UDRP Report

110, 116 York Street

**RE: Response to UDRP Recommendations – April 4, 2025
110, 116 York Street**

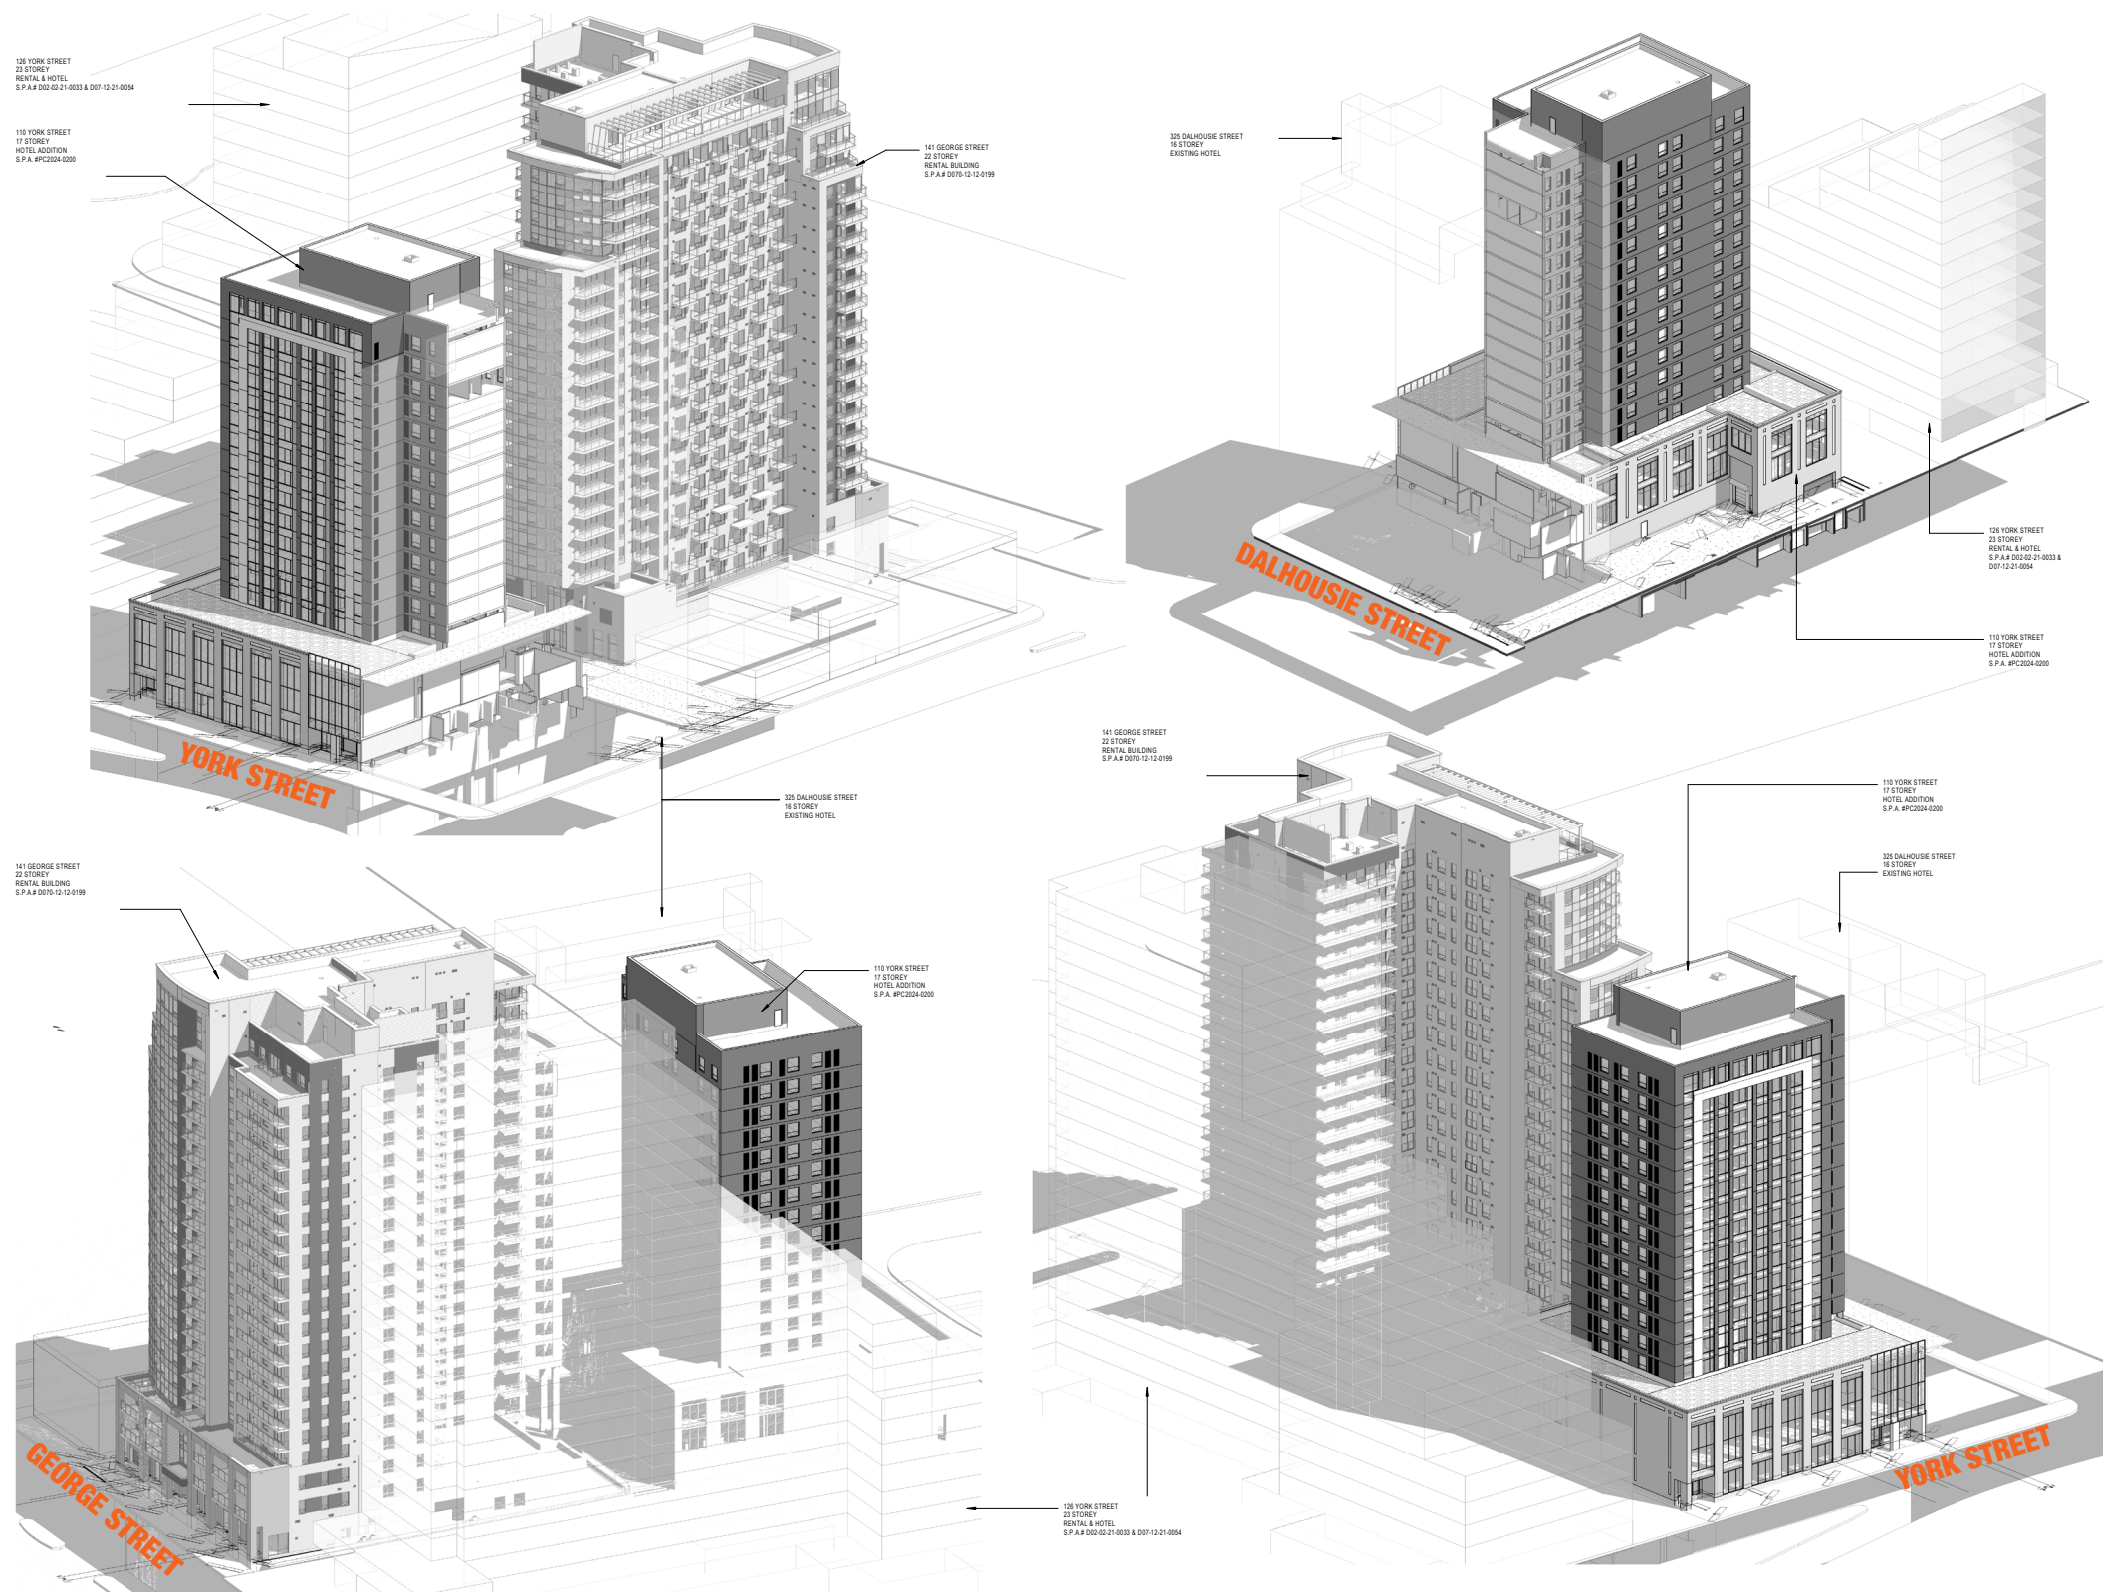
City Comment 22: The following element of the preliminary design are of concern:

- a. Active frontage facing York Street.
- b. Blank wall facing east should consider quality materials showing sensitivity to the heritage nature of the ByWard market and the neighbouring development.
- c. Tower floor plate size. Why are the towers connected? Is this the best approach? Shadow impacts will be reviewed.

- a. **Design proposes significant transparency of the active frontage on York Street, in line with ByWard market policy, creating foot traffic east of the district.**
- b. **The material and fenestration of the east façade of the development is proposed to be a continuation of the north façade, considering the use of the podium. There is potential for a mural on the east façade, which may incorporate references to the heritage of the area.**
- c. **The proposed development is an extension of the Andaz Hotel and some connections between the buildings will be provided. A stairwell will connect the main lobby of the existing Andaz Hotel to the second storey of the proposed hotel extension.**

Landscape Plan

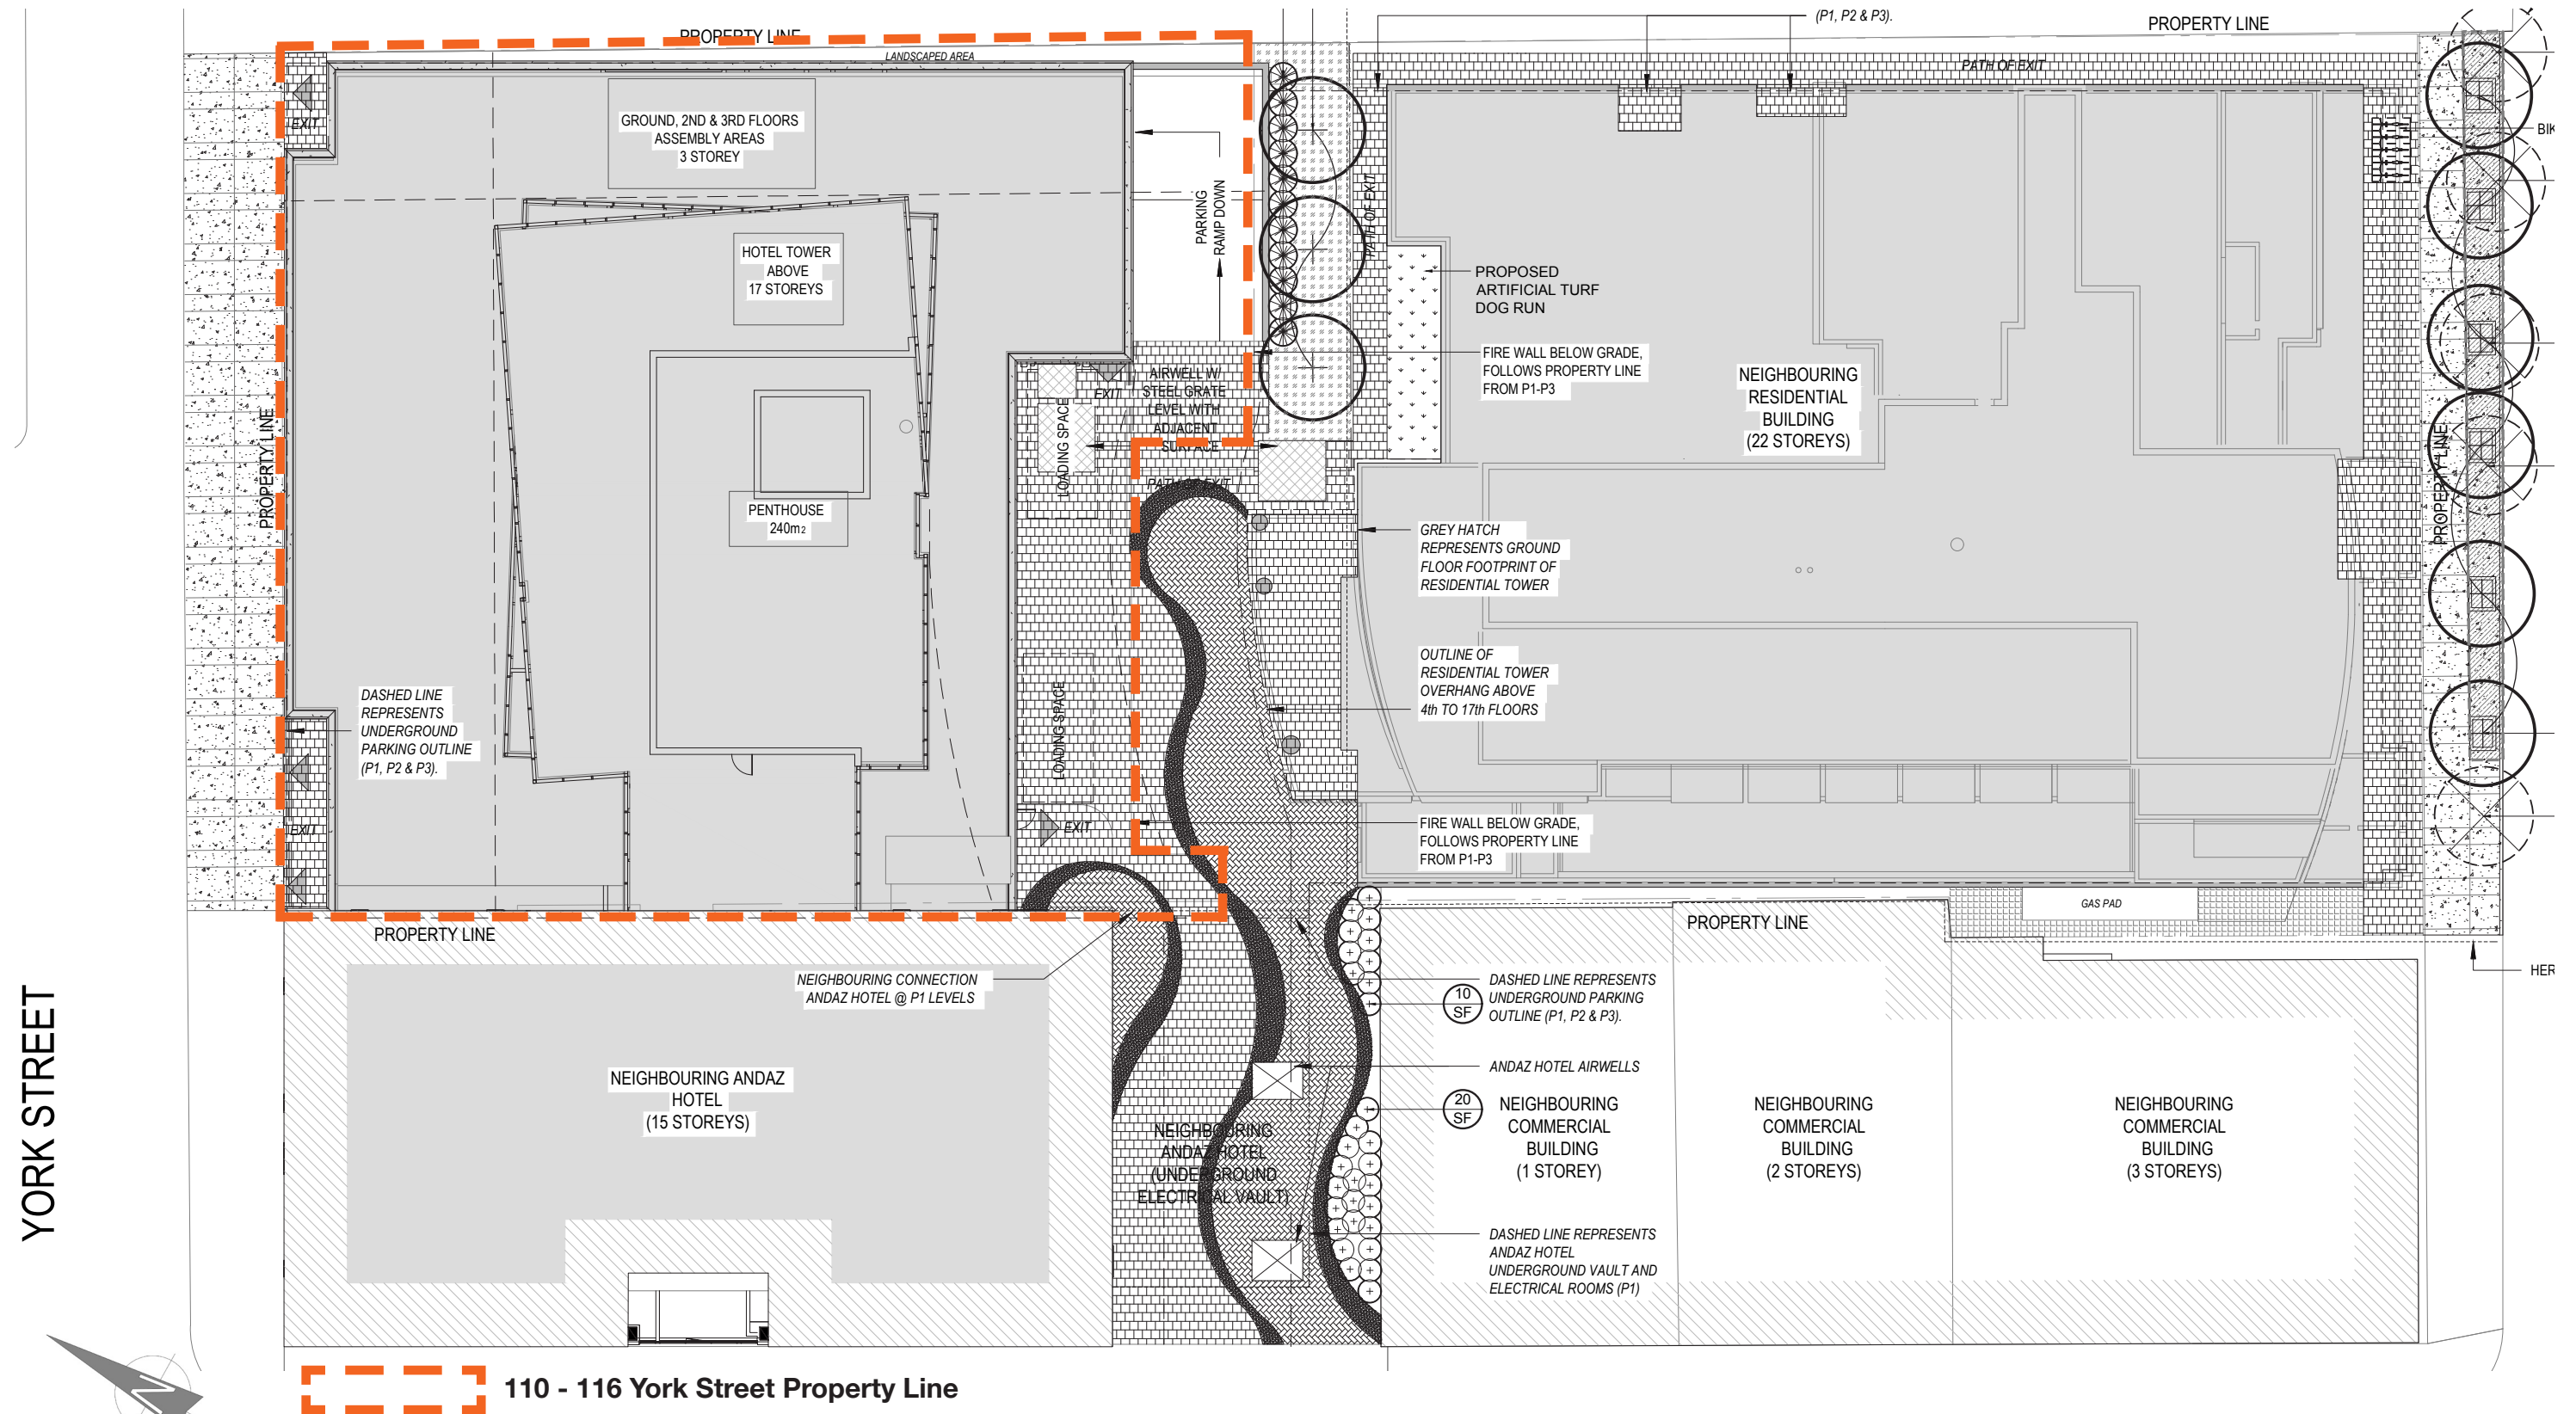
10. The Panel expresses concern with the laneway treatment at the rear of the site. While currently functioning as a service zone, the proposed paving patterns suggest pedestrian use that is unsupported by program, animation or safety measures.

/ The Panel suggests that the design intent should be clarified—either refine it as a high-quality service lane or transform it into a shared space that accommodates both people and vehicles with appropriate design cues.

/ The Panel suggests introducing additional soft landscaping, particularly within the courtyard and along the perimeter, to mitigate the urban heat island effect.

Response: Please refer to the response to Comment 4. The laneway is a high-quality service lane and access to the parking garage. Design elements are incorporated to make it visually appealing to residents and hotel guests in the surrounding buildings.

Response: The City requested vehicular access and traffic be removed from York Street, which required the hotel loading spaces and public parking access to be directed to the area between towers, reducing the ability to provide further soft landscaping. Light-coloured paving aids are proposed to mitigate urban heat island effect. Trees and shrubs are proposed within the courtyard and abutting the neighbouring commercial building on Dalhousie Street to screen the ramp to the parking garage and provide heat mitigation.

North Elevation

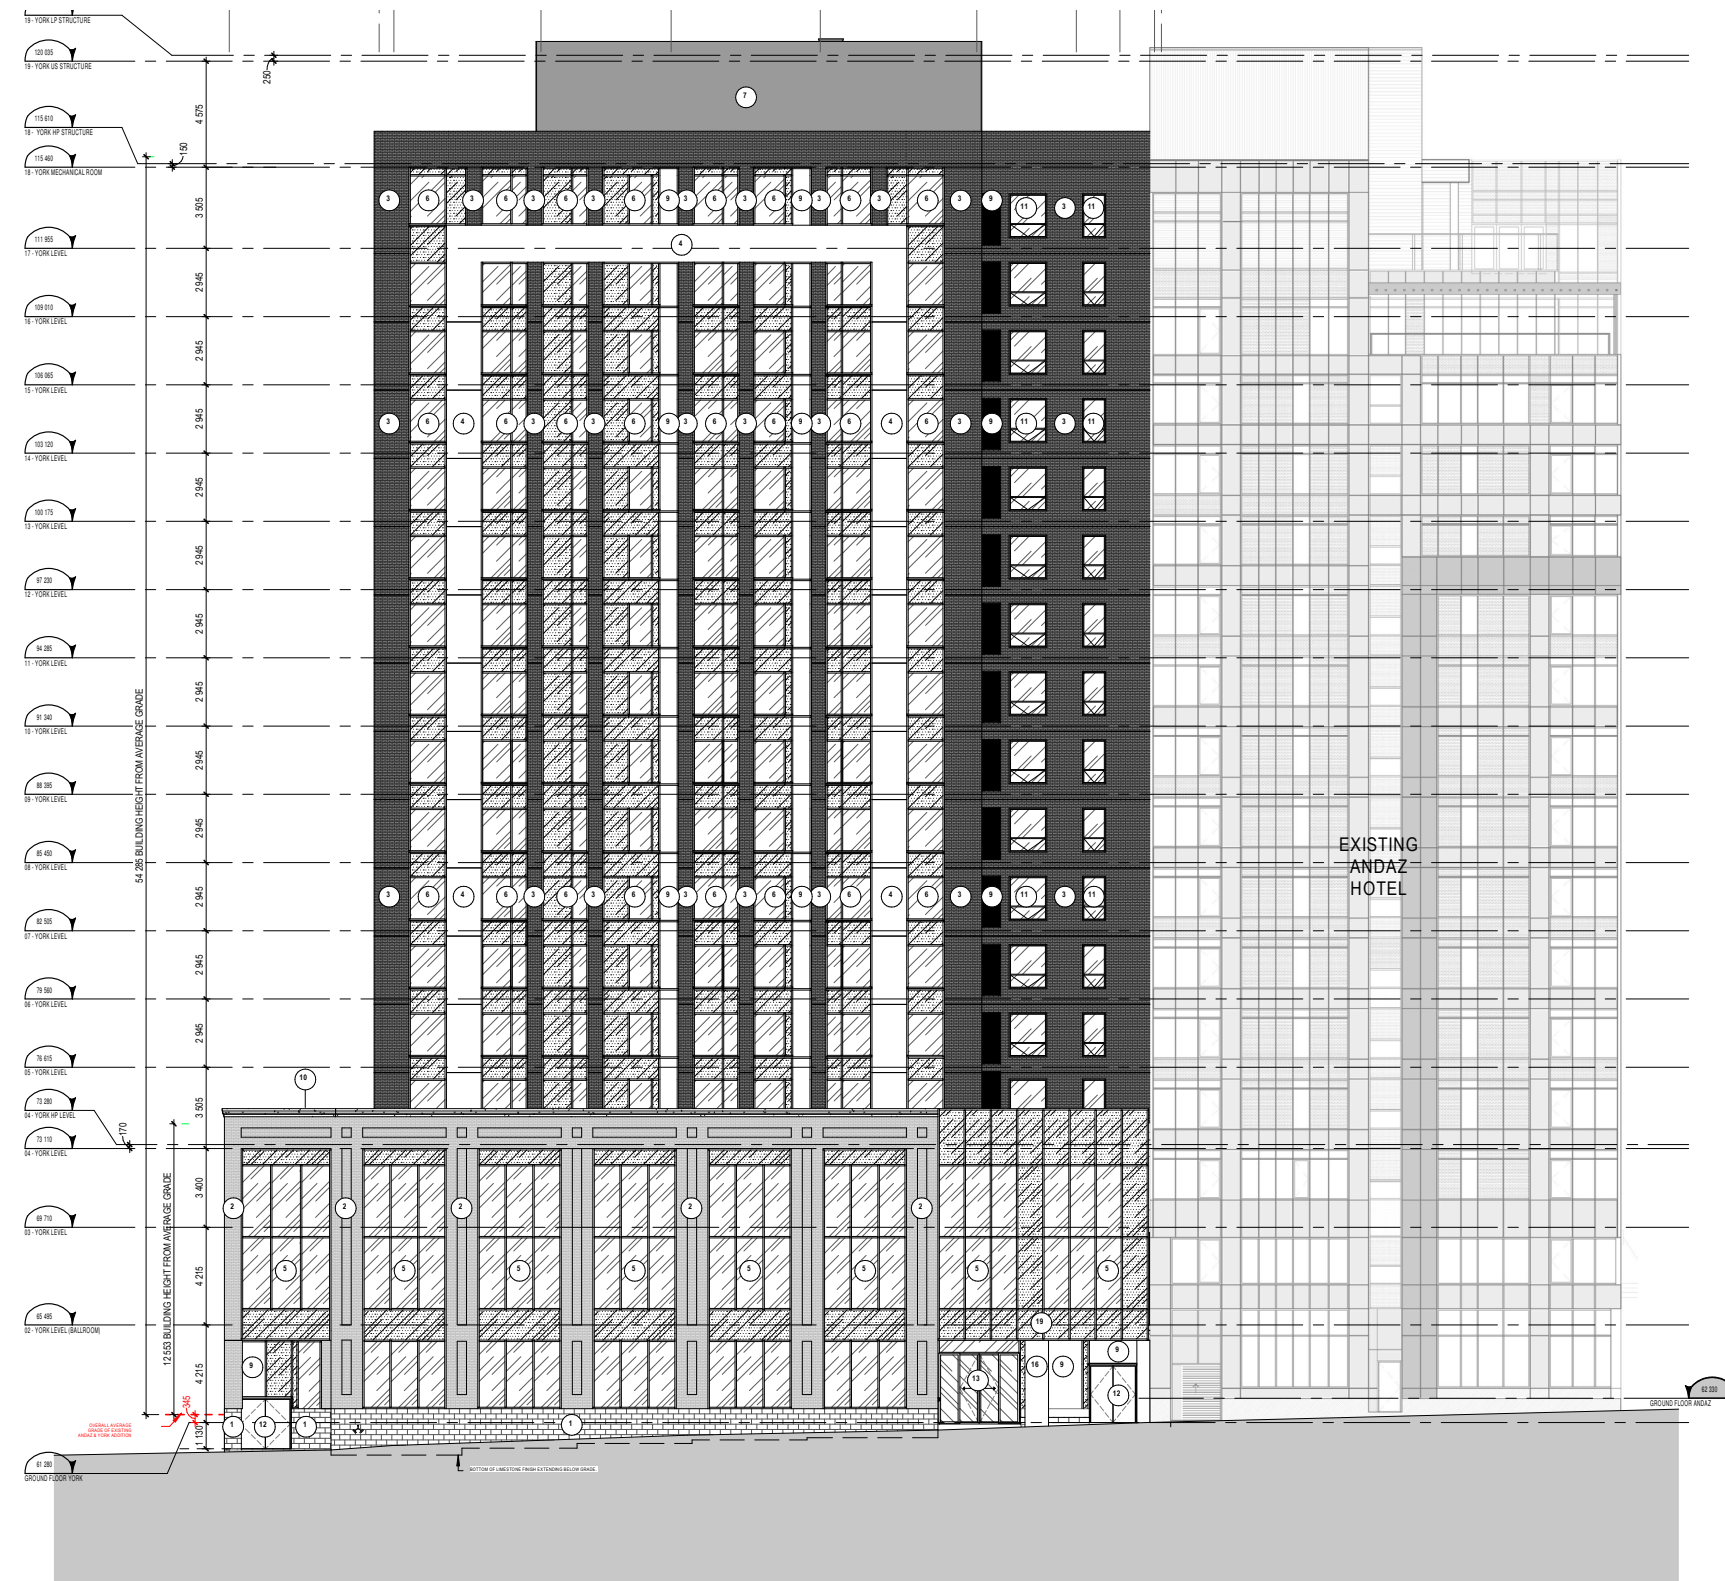
5. The Panel expresses general support for the materiality of the podium and initial design moves but identified issues with the flatness of the podium façade.

/ A higher quality, more articulated design and solidity is needed to align with the fine-grained texture of the surrounding neighborhood.

12. The Panel encourages stronger architectural articulation at both the podium and tower levels.

/ The current podium is perceived as overly flat and lacking the richness and solidity expected within a historic urban context. Greater detailing and modulation are recommended to better reflect the scale and texture of the surrounding buildings.

Response: In response to the Panel's feedback, recessed brick panels are proposed on the podium cladding, increasing the animation, light and shade of the building façade. The cornice on the top of the podium aligns with the design of buildings in the surrounding area.

Response: A decorative cornice is applied to the podium parapet and brick recesses around podium windows are shown on elevations. The glass volume over the main entrance will be recessed back to create variety between the existing Andaz and new brick podium facades.
